DRAFT REPORT ON

GARDINER EXPRESSWAY

HUMBER RIVER BRIDGE REPLACEMENT PROJECT

BRIDGE 1 AND SOUTH KINGSWAY ON-RAMP

GENERAL AND LOCAL SCOUR
 FIGURE 1

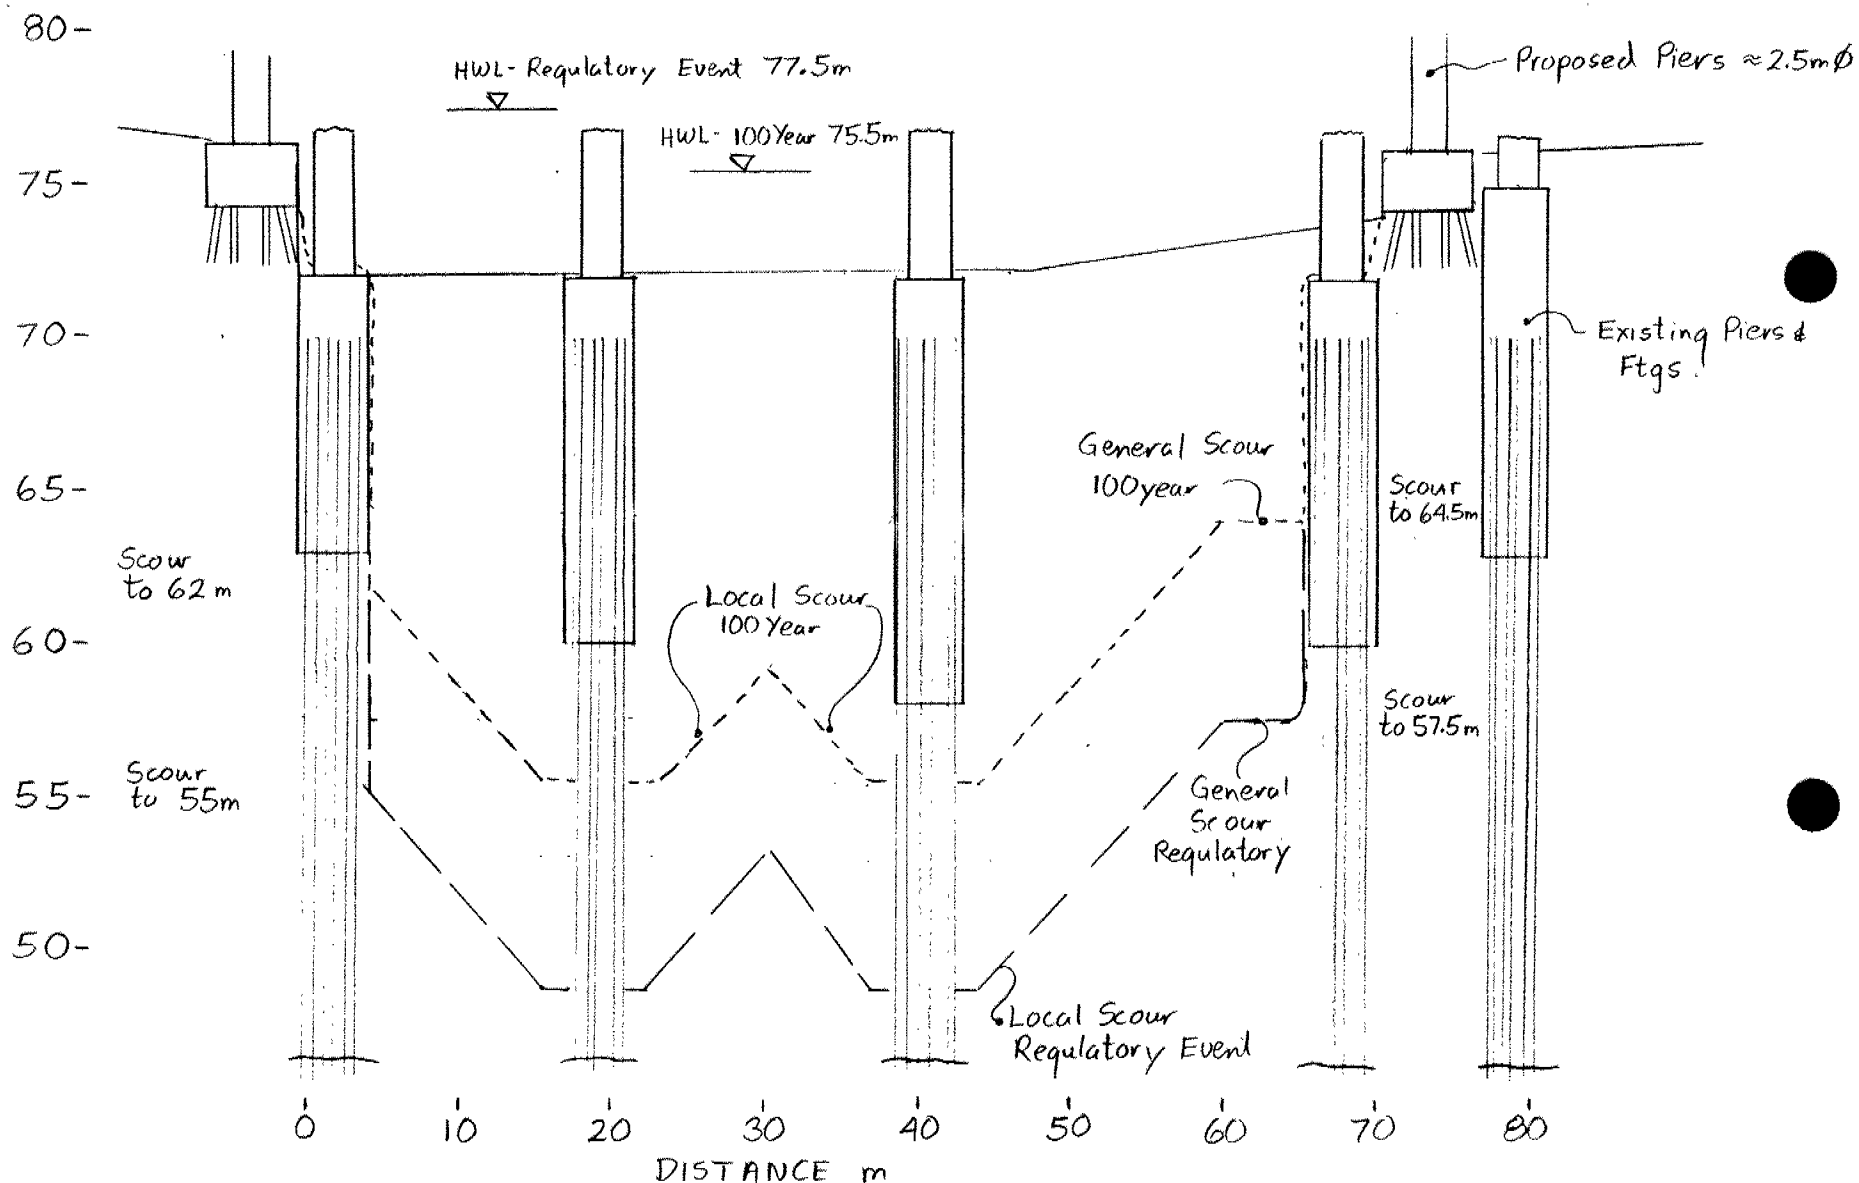
Due to the existing piers within the channel, the channel section through the existing Lakeshore Boulevard bridge has been used to estimate general and local scour. A cross-section of the channel perpendicular to the flow is attached as Figure 1.

The local scour has been added to the general scour on Figure 1 and would result in an increase in the scour depth at the west bank by about 2.5 m.

The new piers and footings/piles will need to be designed to accept exposure of the piles down to elevation 55 m during the Regulatory flood. Alternatively, bank protection using sheet steel piling driven below elevation 55 m would be required to protect the channel bank from scour and erosion and to maintain the integrity of the river bank piers.
